DATE: December 7, 2020  
TO: Potential Respondents  
FROM: Elaine Robbins – Construction Solicitation Coordinator  
SUBJECT: Questions #1  
RFCSP769-21-10742ER  
UNT Art Studio Facility & Oak Street Hall Demolition

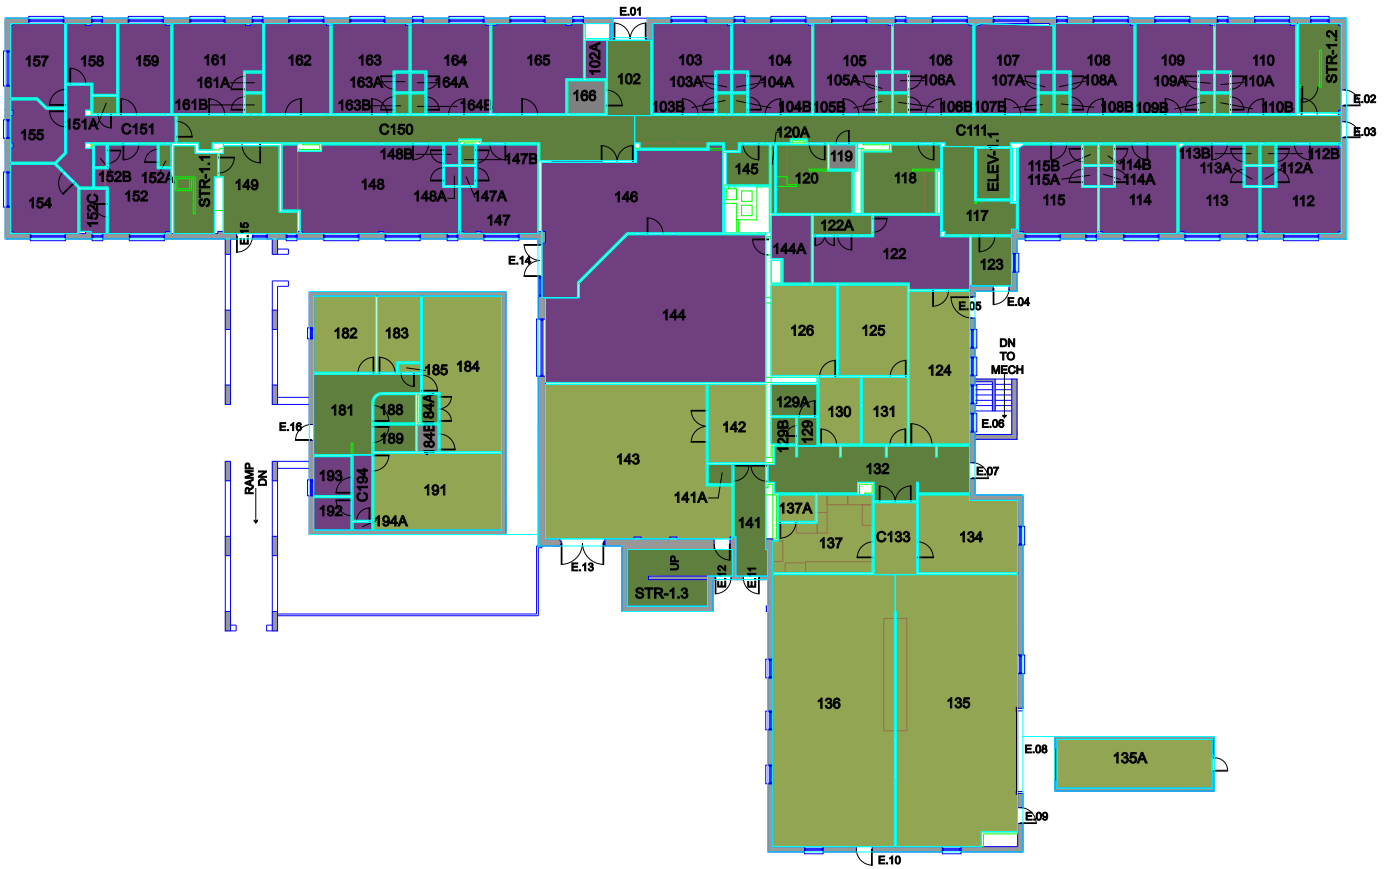
26. A-201-A-203 / Exterior Elevations – plans do not show any signage; is Building Signage required?

**ANSWER: *No exterior building signage is required from GC; it will be provided by UNT Sign Shop.***

OSH BY DEPT

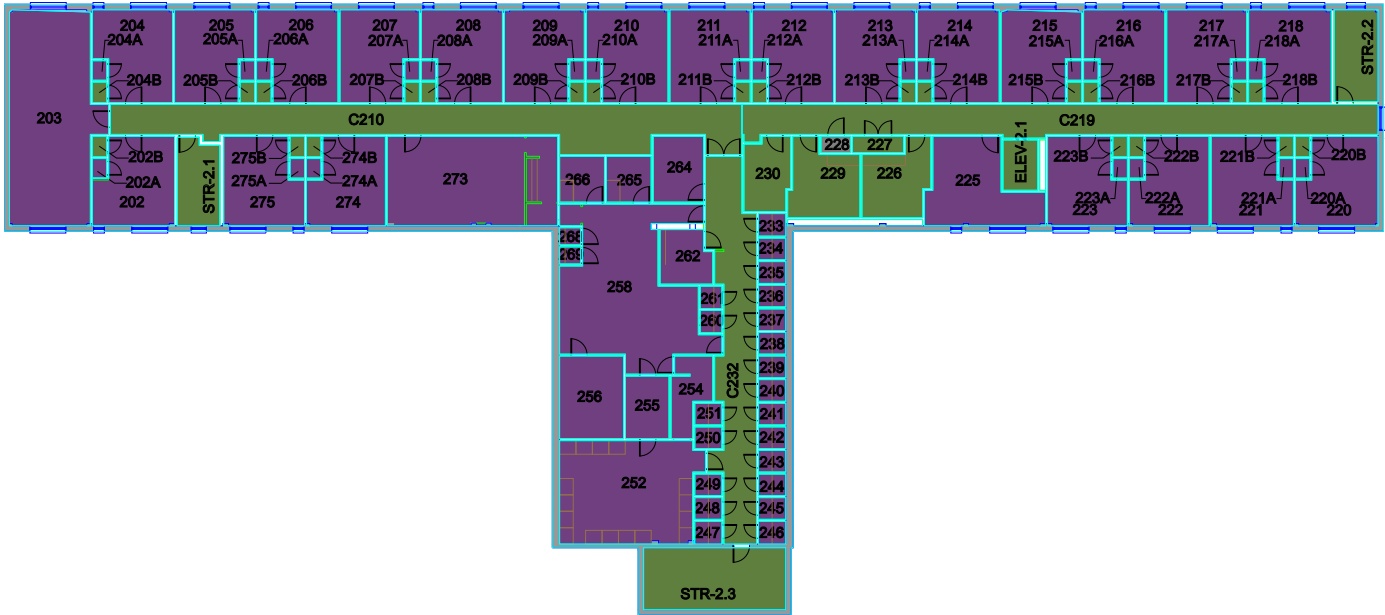
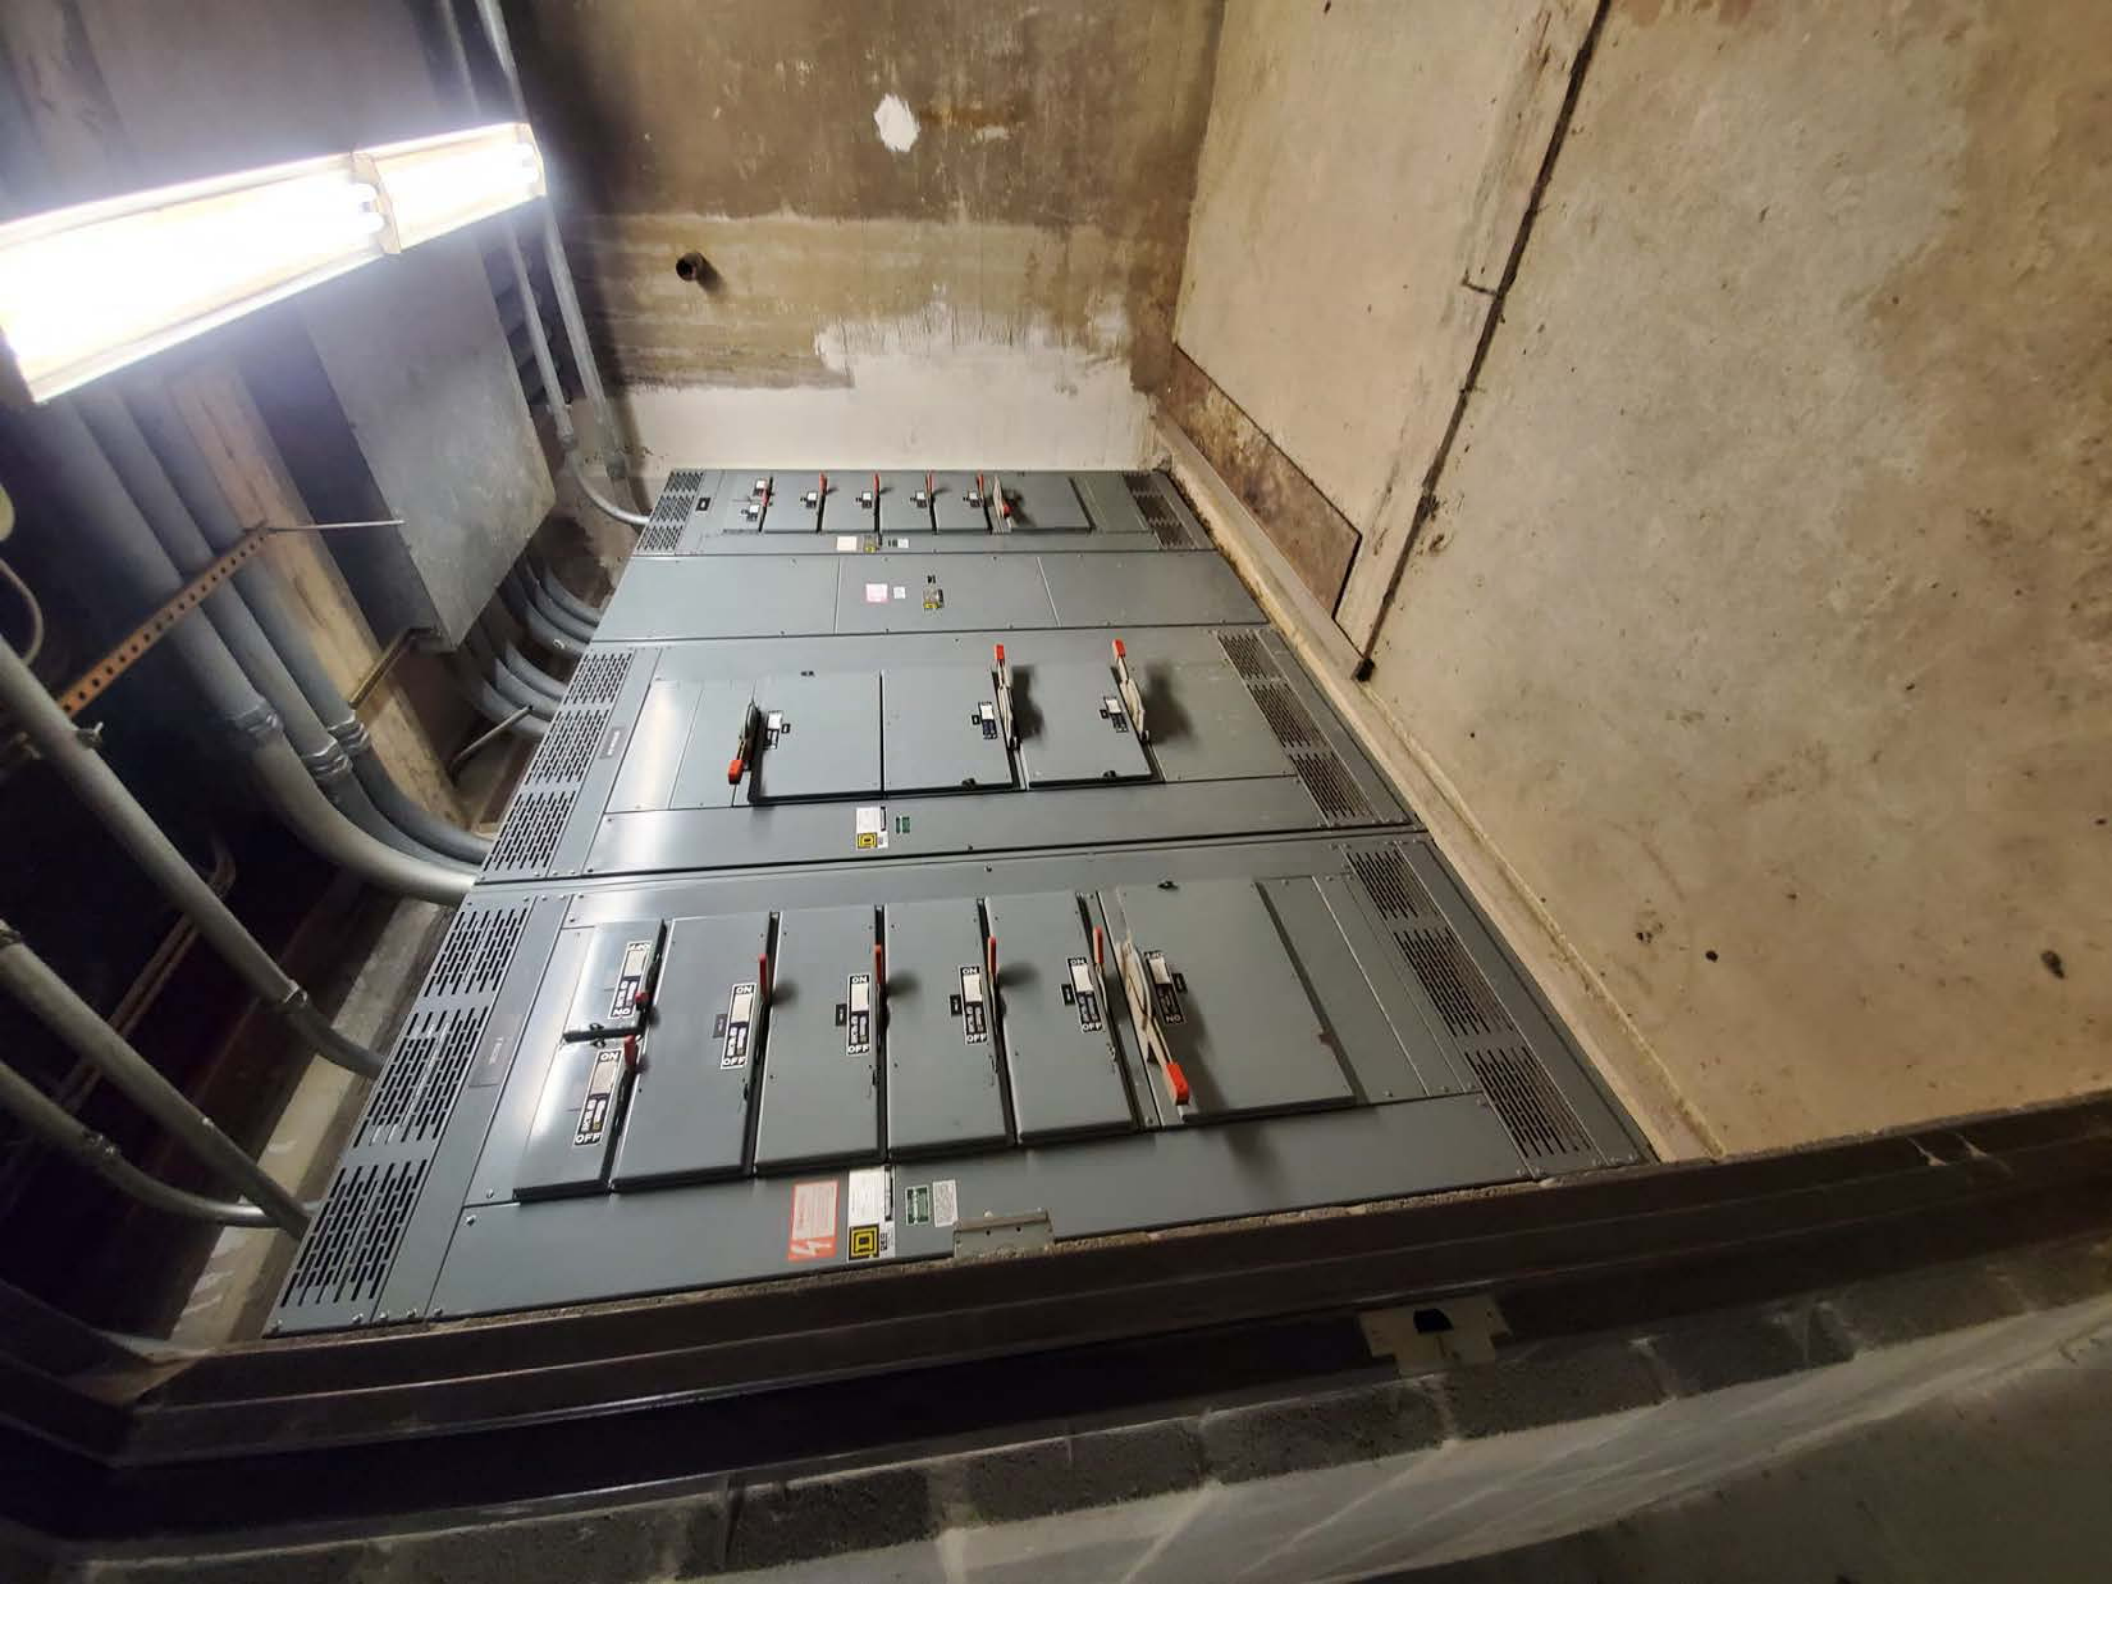
15. As discussed during the Prebid meeting, please confirm that since Oak Street Hall is 85% vacant; there should be minimal downtime between turnover of Art Studio and Demolition of Oak Street Hal.

16. Can the demo of Oak Street Hall be done concurrently with the construction of the new building?

**ANSWER: *Oak Street Hall is approximately 85% vacant. The Studio Arts-Ceramics department is currently the only occupants in the building(s). See attachment for visual clarification on these spaces. With adequate, detailed move coordination in place, the Studio Arts-Ceramics' transition from Oak Street to the new facility should be minimal. The only caveat is that Ceramics' offers classes in the Fall and Spring only. If the Art Studio construction is complete in February, we will need to allow them time to complete the Spring semester. Systematic scheduling needs to be considered and presented.***

**ANSWER: *No, the Studio Arts-Ceramics department currently occupies a portion of the building. See attachment for visual clarification on these spaces.***
